**RE: Skilled Nursing Facility, 1610 Renaissance Blvd NE
Grading and Drainage Plan
Engineer's Stamp Date 7-17-2015 (File: F16-D017)**

Based upon the information provided in your submittal received 7-16-15, the above referenced is approved for DRB action on the Site Development Plan for Building Permit. It will not be approved for Building Permit until the following comments are addressed:

RE: Skilled Nursing Facility 1610 Renaissance Blvd NE (File F16-D017)

SKILLED NURSING FACILITY RENAISSANCE CENTER	DRAWN BY DY
	CONCEPTUAL GRADING AND DRAINAGE PLAN	DATE 7/16/15
2014088-GRE		SHEET # C2
5571 MIDWAY PARK PLACE NE ALBUQUERQUE, NM 87109 (505) 858-3100 www.tierrawestllc.com		JOB # 2014088

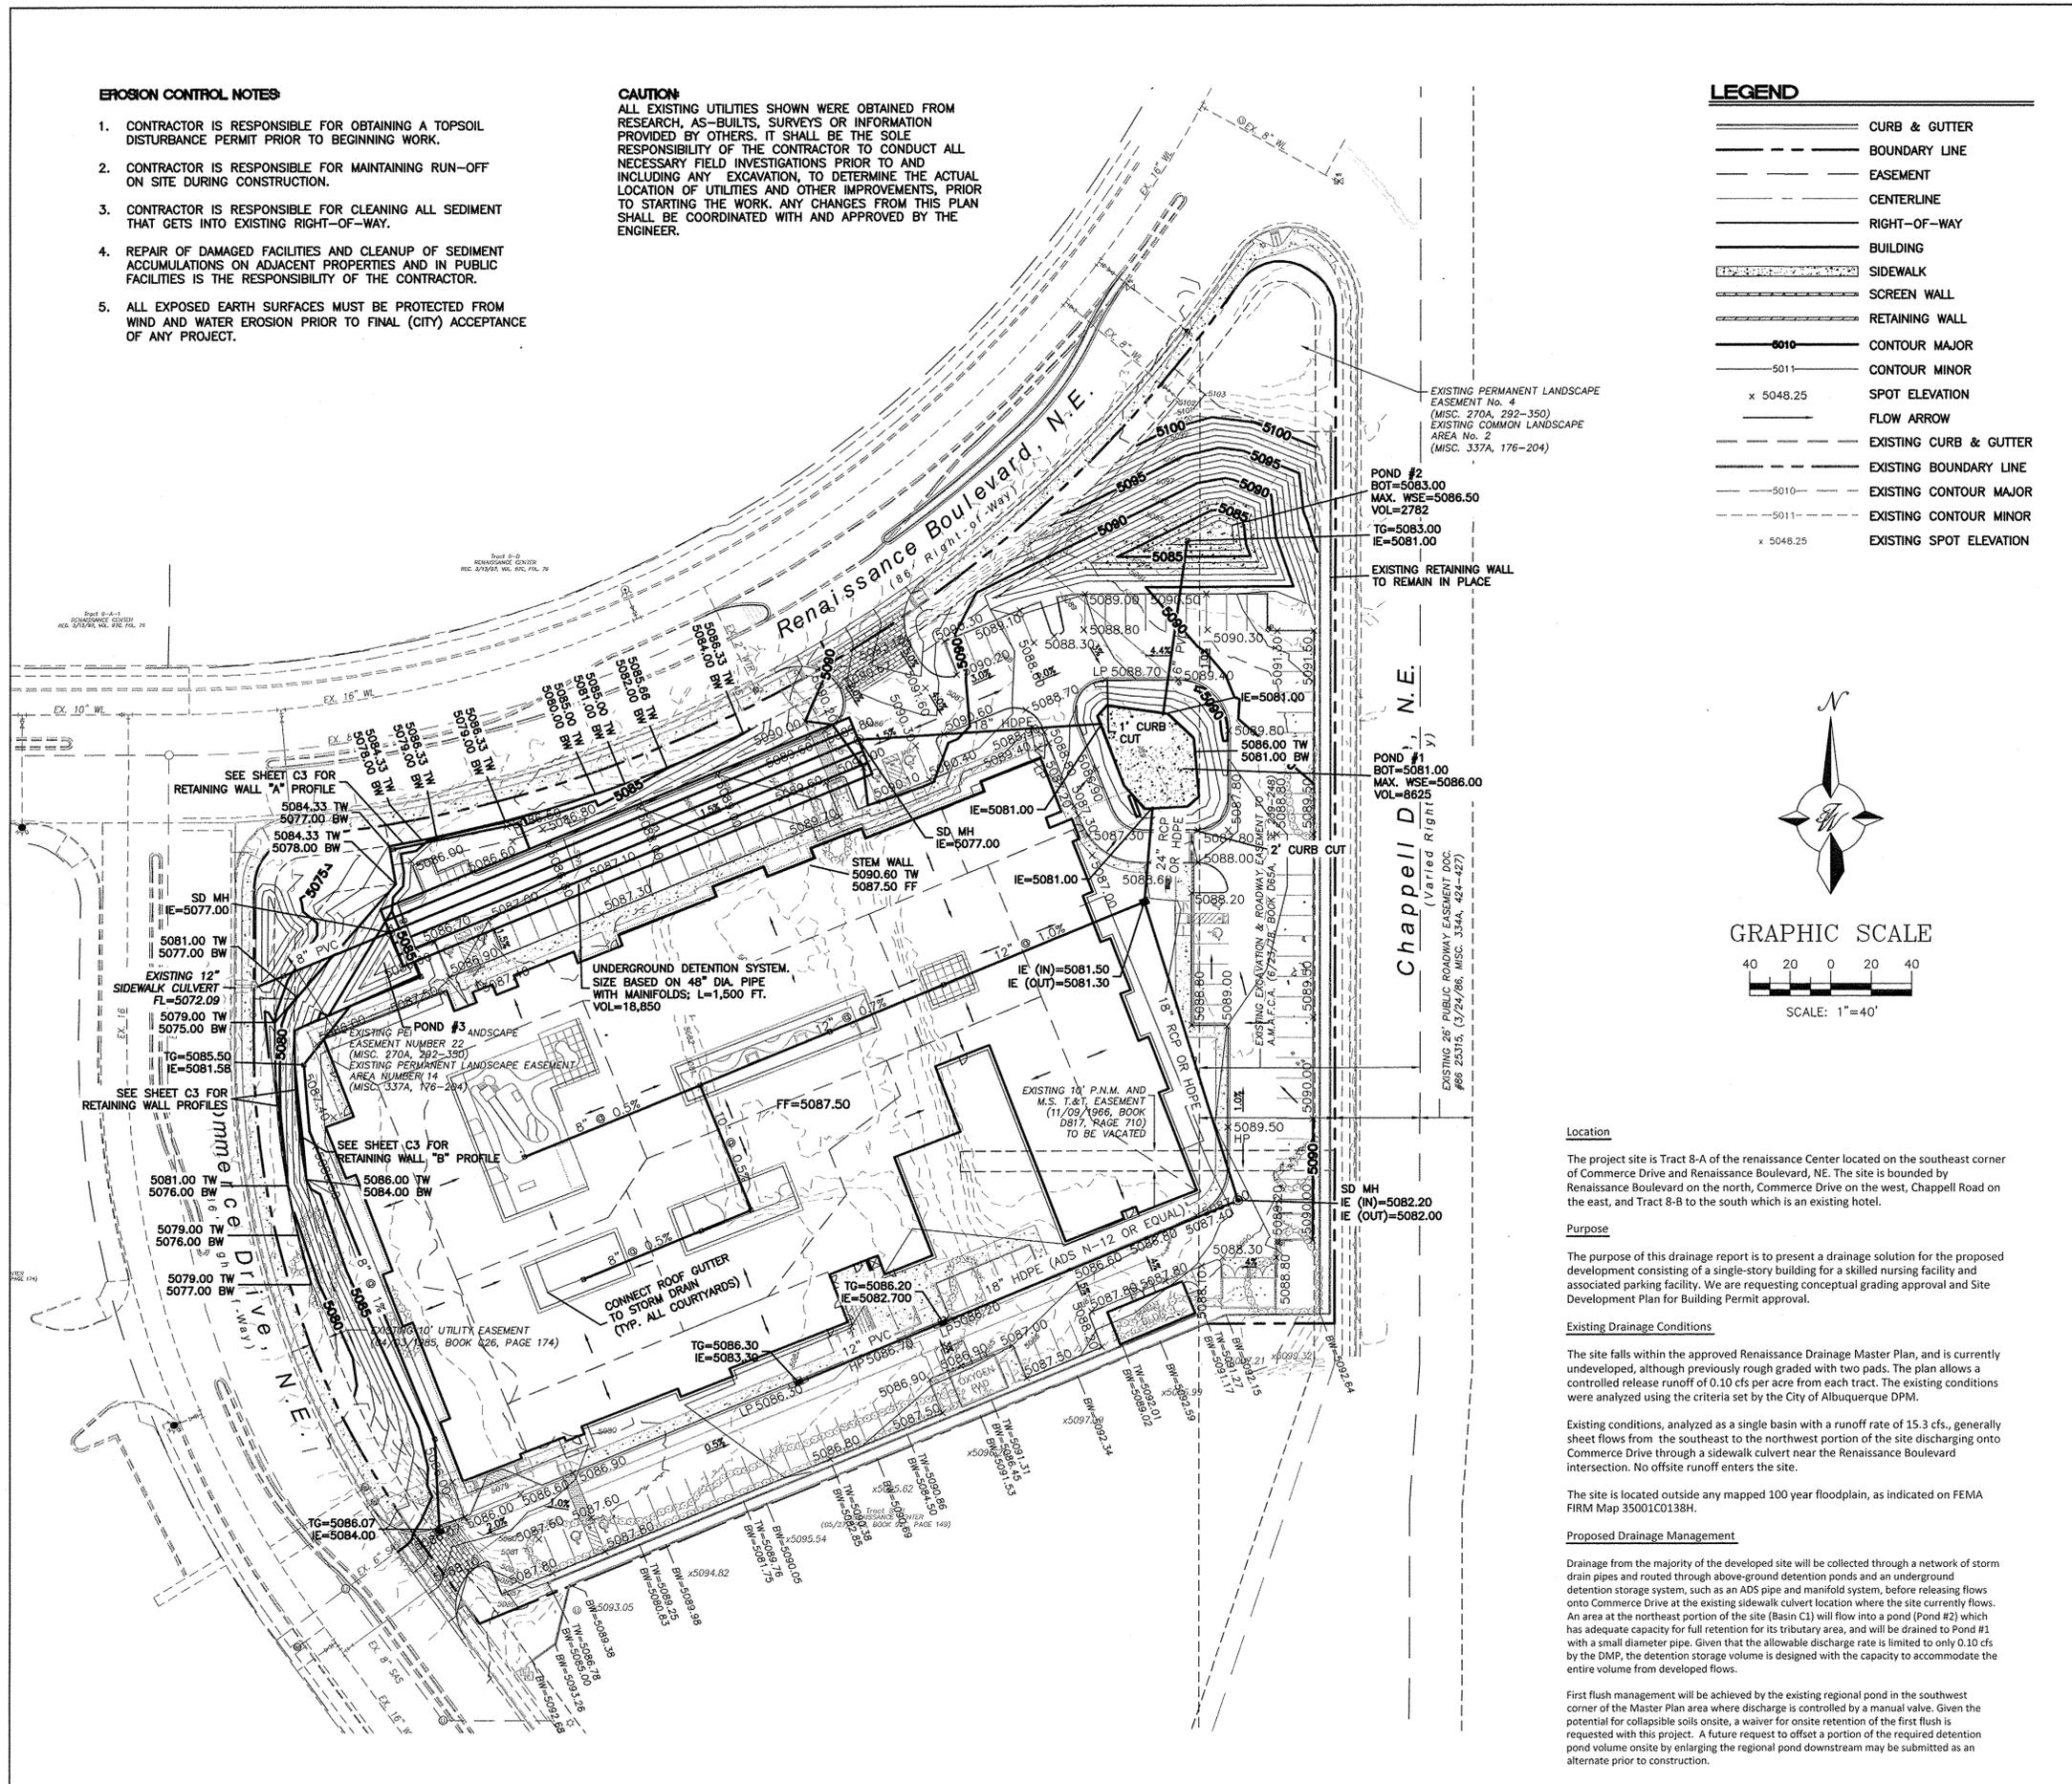
- 1) The request for the waiver for the first flush requirement needs further discussion. One option is to discuss with COA DMD about use of the regional pond for first flush management. Also, another option is to utilize retention ponding further away from the building, but there were no details provided about whether or not the geotechnical recommendations would not allow retention ponding within a certain distance from the building. Is there a possibility that the pond furthest away from the building could be used for retention ponding?

- 2) Label existing spot elevations, and label existing contours on Chappell Drive and on Commerce Drive. Especially show the existing curb elevations at the access points. Take ADA access across the accessways into account.

- 3) Pond 3 is called out on two opposing locations on the grading and drainage plan versus the basin map. This pond appears to be too close to the building on the actual grading plan. No information for it is shown. Was it meant to keep this pond or eliminate it? Revise contours accordingly.

- 4) Hatching appears to show concrete bottoms for Ponds 1 and 2. Provide details as applicable.
- 5) For **all** proposed storm drains, show the flow, slope, and capacity computations. Also, show capacity computations for the proposed inlets.

- 6) There is a spot elevation of 5086.90 that looks like it is at a low spot west of Pond 1. Provide curb cut at the low spot. Provide more spot elevations to show drainage around the curb within this area.

- 7) More detail is needed for the underground detention system. Also, given that these proposed 48" pipes are shown to be flat, how will they be maintained since sediment will easily build up within these pipes? Show details of how the manholes are connected into each end of the system. It appears that there is limited access to maintain the system. Also, what types of pipes are being used?

- 8) A detail is needed for the connection of the 8" pipe into the existing sidewalk culvert. At the connection to the existing culvert, label the proposed discharge flow.
- 9) The land treatment percentages for both Basins C3 and D1 look incorrect since they appear to have a much higher percentage of impervious area than what is shown in the computations.

- 10) Between the discharge to the culvert and the discharge from Basin D1, demonstrate that the site does not discharge more than the allowable discharge of 0.1cfs/acre.

- 11) Label top of grate elevation for the inlet south of Pond 1. List invert and grate elevations for the 8-inch to 12-inch sized pipe through the center of the building.
- 12) In the legend, distinguish between existing and new TW and BW elevations. Provide new wall details as applicable.

- 13) For volume computations, demonstrate that the site discharges 90% of the design storage volume within 6 hours. Use of the 100-year 24-hour storm volumes and distributions will be required for higher times of concentration per the storm drainage ordinance.
